Planning Commission Staff Report

Subject: Rezoning Issues Report

Petition: P.Z. 24-2007 Mark Andy Inc.

MARK ANDY, INC.
PRELIMINARY DEVELOPMENT PLAN

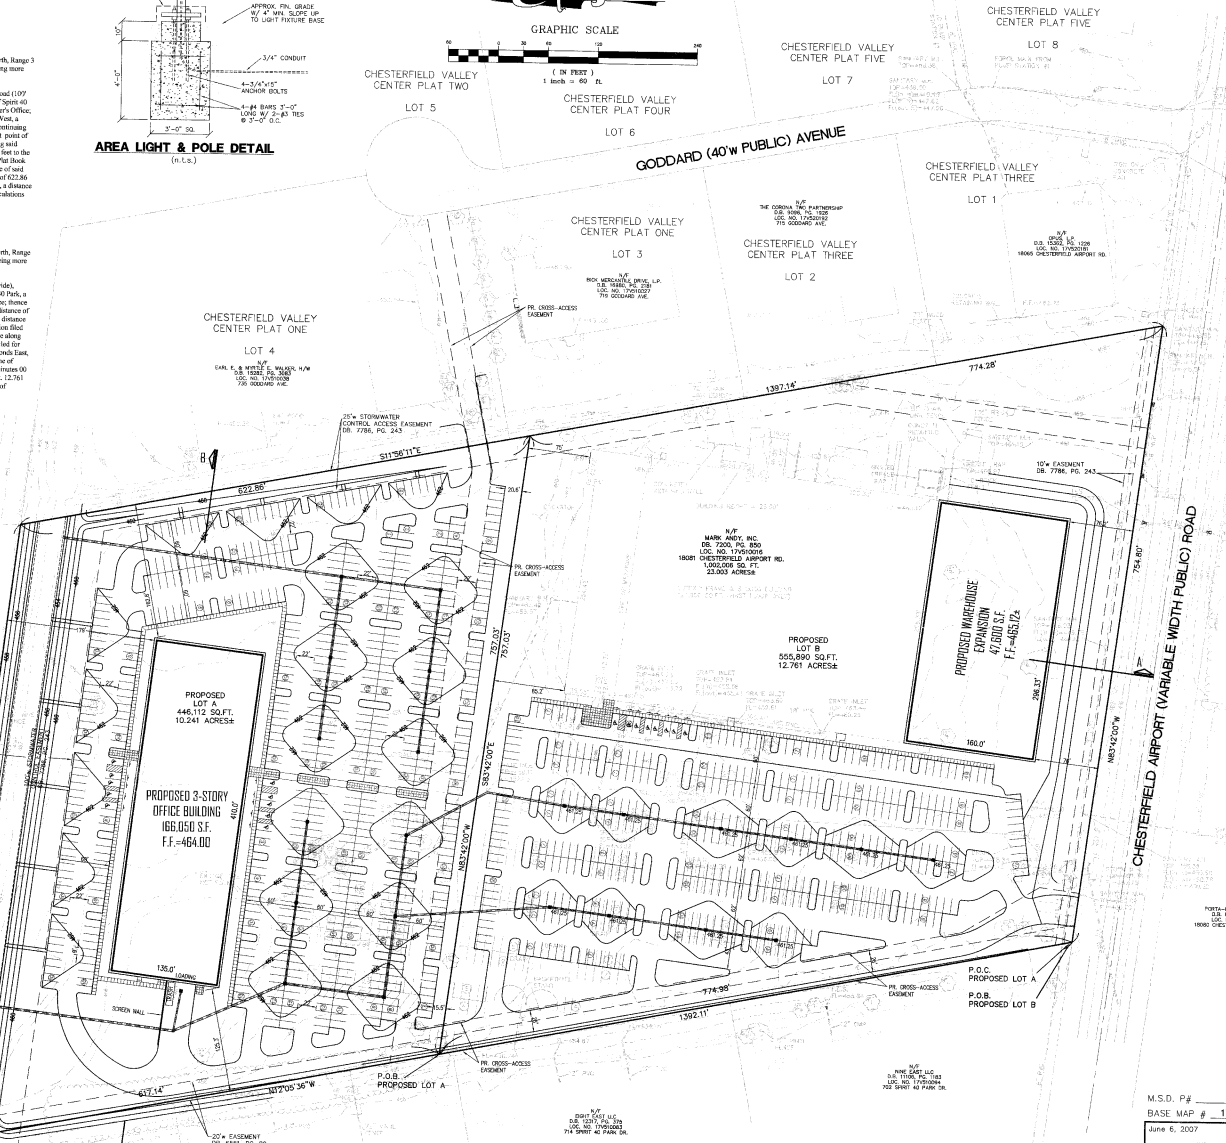
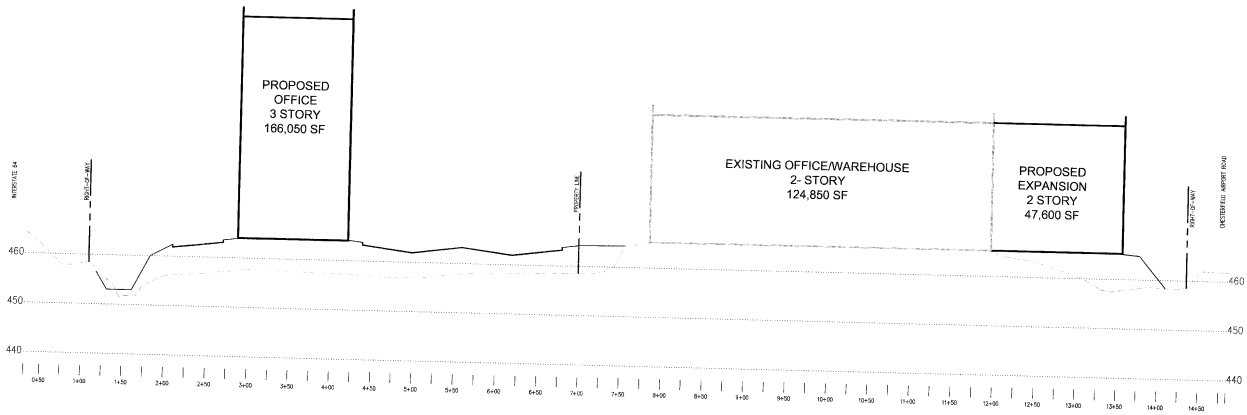
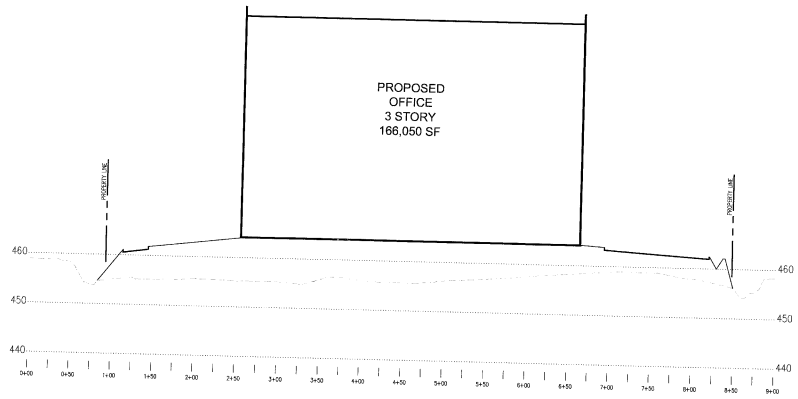
The plan indicates the possibility of obtaining cross access to Goddard Avenue. While this connection is encouraged, parking shall not be allowed along the drive lane connecting the subject tract to Goddard Avenue and the number of drive isles connecting to it shall be limited.

The plan indicates using the western most existing entrance as the main entrance for both lots on this site. This existing entrance does not meet the desirable minimum separation between it and the existing entrance in the adjacent lot to the west (Lot 9, Spirit 40 Park). If the existing entrance is to be utilized, cross access shall be provided to the adjacent subdivision and the entrance to Lot 9, Spirit 40 Park, shall be removed. If this cannot be accomplished the entrance to the site shall be aligned with the existing entrance on the south side of Chesterfield Airport Road.

St. Louis County Highways and Traffic have submitted the comment that "Access to this development from Chesterfield Airport Road shall be restricted to one (1) commercial entrance, located to provide required sight distance and constructed to St. Louis County standards as directed by the St. Louis County Department of Highways and Traffic. This commercial entrance shall provide separate right and left turn lanes for existing traffic for a minimum distance of 150 feet. There shall be no minor driveways or parking aisles intersecting this main driveway within this 150 foot distance."

2. The plan indicates using the western most existing entrance as the main entrance for both lots on this site. This existing entrance does not meet the desirable minimum separation between it and the existing entrance in the adjacent lot to the west (Lot 9, Spirit 40 Park). If the existing entrance is to be utilized, cross access shall be provided to the adjacent subdivision and the entrance to Lot 9, Spirit 40 Park, shall be removed. If this cannot be accomplished the entrance to the site shall be aligned with the existing entrance on the south side of Chesterfield Airport Road (Porta-Fab, 18080 Chesterfield Airport Road).

The Petitioner requests that *"There is a possibility of obtaining a cross access easement to Goddard, but this is subject to negotiation with the affected adjoining property owners. The cross access easement, if acquired by negotiation, will only be a drive aisle; thus, parking should be allowed along the drive aisle as it is allowed in other similar situations."*

The Petitioner states that *"The Petitioner has no control with respect to the access on adjoining properties (which are already developed and built), and it would not be reasonable to condition the zoning of the subject property on the elimination of an existing access point on adjoining property. Petitioner is agreeing to provide cross access along its western boundary that could be used at such time as the adjoining property is redeveloped. The southern portion of the subject property is already developed and built with an existing manufacturing facility and associated parking; therefore, it would not be reasonable to require realignment of the existing access at Chesterfield Airport Road so that it aligned with an existing access on the south side of Chesterfield Airport Road."*

The petitioner will work with St. Louis County Highways and Traffic with regard to this requirement. The Department of Planning and Public Works is aware of this comment and has no issue with the number of entrances shown on the preliminary plan.

Response: Petitioner has no control with respect to the access on adjoining properties (which are already developed and built), and it would not be reasonable to condition the zoning of the subject property on the elimination of an existing access point on adjoining property. Petitioner is agreeing to provide cross access along its western boundary that could be used at such time as the adjoining property is redeveloped. The southern portion of the subject property is already developed and built with an existing manufacturing facility and associated parking; therefore, it would not be reasonable to require realignment of the existing access at Chesterfield Airport Road so that it aligned with an existing access on the south side of Chesterfield Airport Road.
